**TRINITY COUNTY PLANNING COMMISSION  
STAFF REPORT**

**PROJECT NAME:** Lance Gulch Road/State Route 299 Intersection Control Project

**PROJECT NUMBER:** PW-16-06

**RESPONSE TO COMMENTS FROM SCOTT WHITE  
LETTER DATED NOVEMBER 2, 2016**

# FIGURE 6 SIGNALIZED INTERSECTION (new)

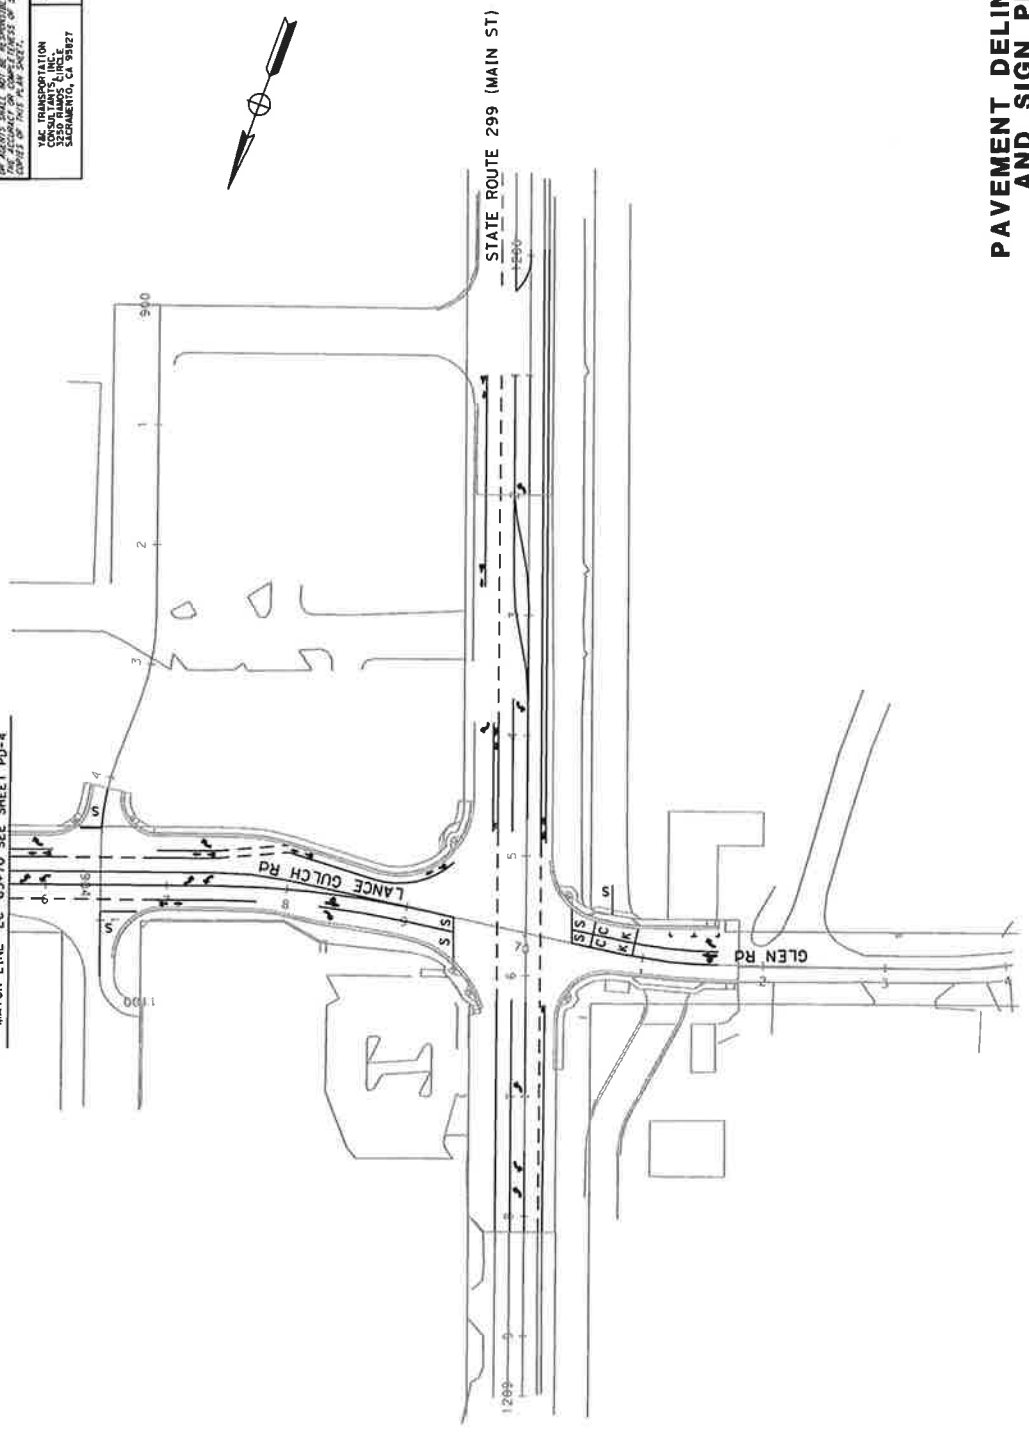
The conclusion that rear-end crashes may increase with a traffic signal because drivers may not expect to encounter a signal on a two-lane highway in a rural county is questionable. Traffic signals are actually located on many two-lane highways in many rural communities throughout rural counties in California, including the seven counties within the Caltrans District 2 area. It seems likely that most drivers would have enough experience to have encountered signals in rural areas and be smart enough to have come to expect them.

COMMENT #8: The document contains speculation that drivers may not expect to encounter a signal on a two-lane highway in a rural county, and rear-end collisions could result. The commenter believes most drivers would have experienced signals in rural areas but would not expect a roundabout on a state highway, since there are none in Caltrans District 2. Comment states that speculation should be eliminated from the Initial Study.

RESPONSE #8: Comment noted. The commenter is correct; speculation is not useful in the environmental analysis or traffic analysis.

**EXHIBIT F**  
**ROUNDAABOUT DESIGN SUGGESTION**  
**FROM JOHN HAMILTON**

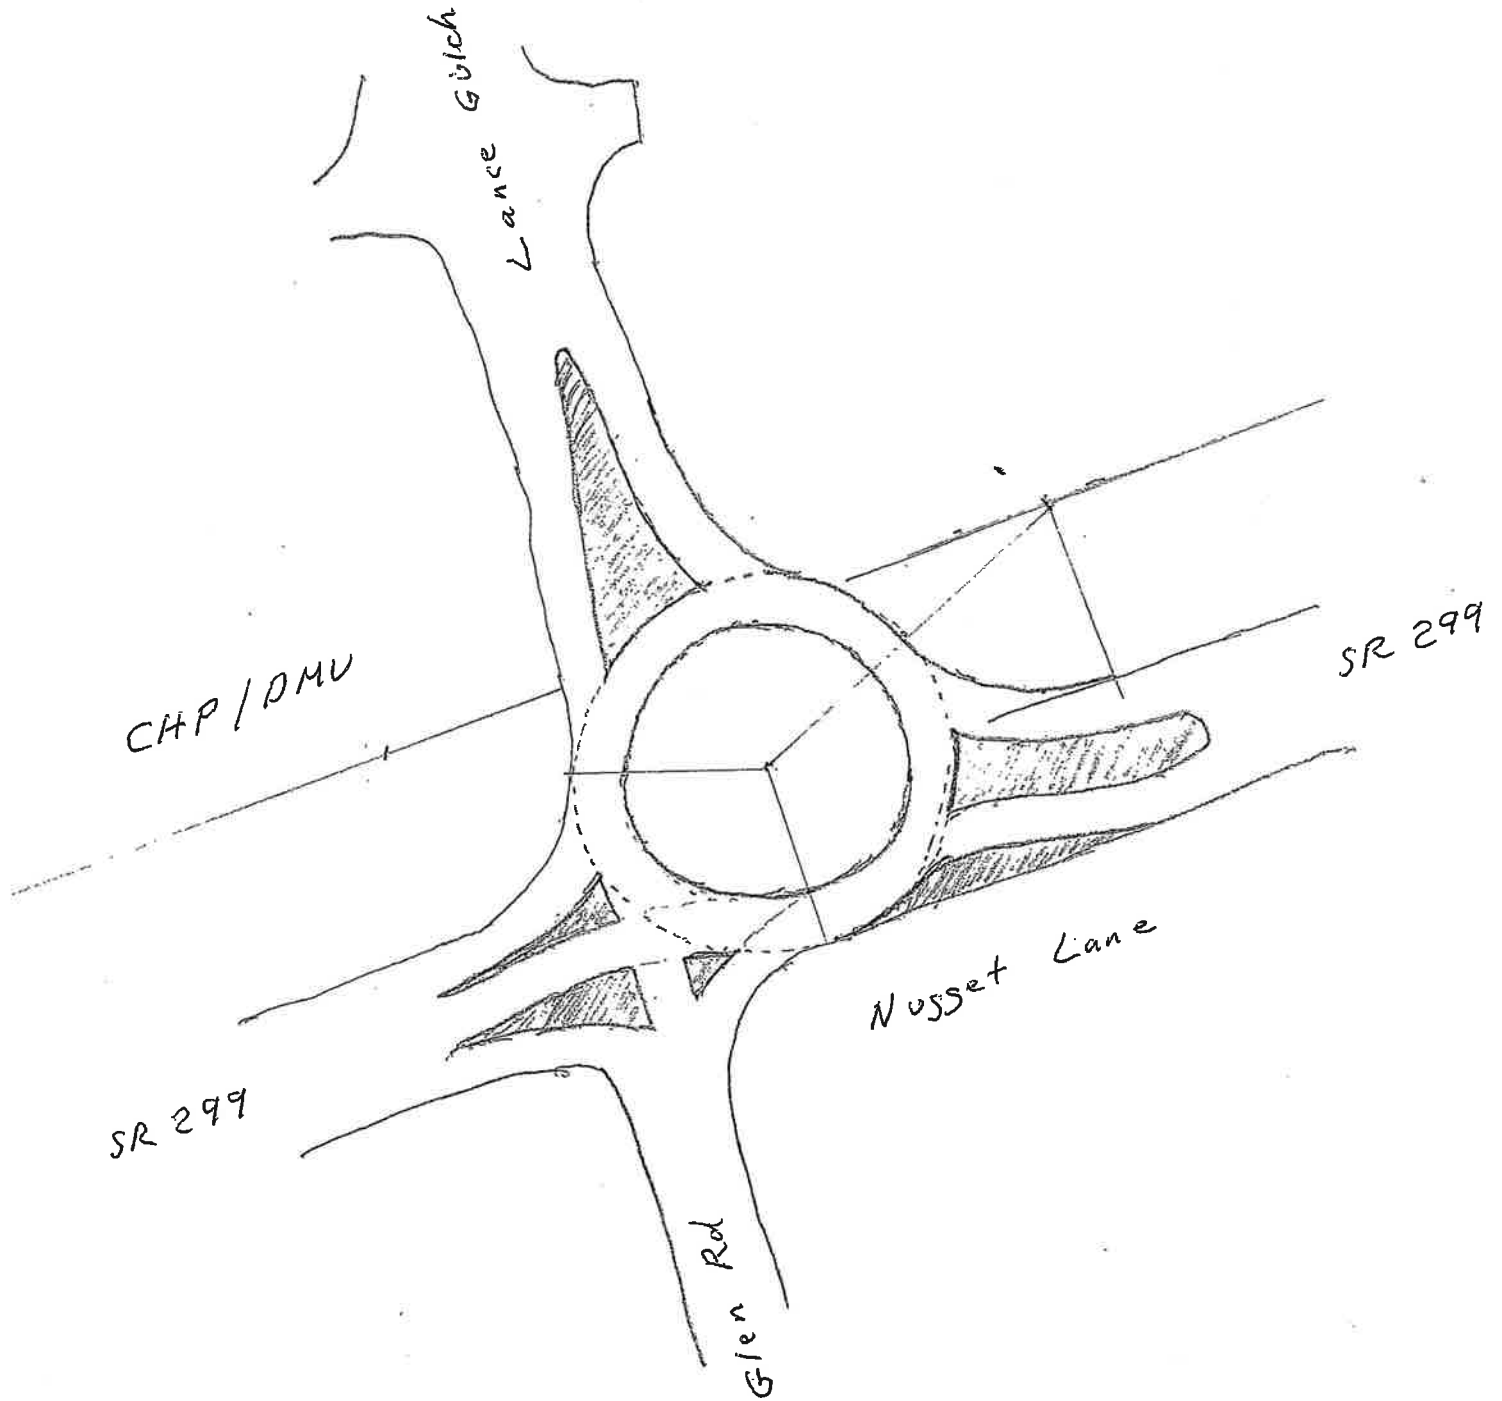
JOHN HAMILTON: Mr. Hamilton provided a drawing of a roundabout that could be constructed closer to the vacant lot adjacent to CVS, without impacting Nugget Lance. He stated that he used to work for a traffic engineer, and that he had presented this concept before but got no response.

RESPONSE: The drawing is attached as **Exhibit F**. Kittelson & Associates, the design consultant for the proposed roundabout, as well as County Engineers and roadway design consultants from Quincy Engineering, consultants for the Lance Gulch Road project all reviewed and commented on the drawing. They found it similar to a drawing that Rob Stinger, Chief of Traffic Engineering & Operations for Caltrans District 2, had provided a couple of years ago, but that was rejected mainly because it eliminated the left turn from westbound SR 299 onto Glen Road, and because it would require realignment and reconstruction of long sections of Lance Gulch Road and SR 299. The roundabout provided by Mr. Hamilton would probably also require realignment of Lance Gulch Road and SR 299, but the drawing has no background or scale so it is difficult to see how much.
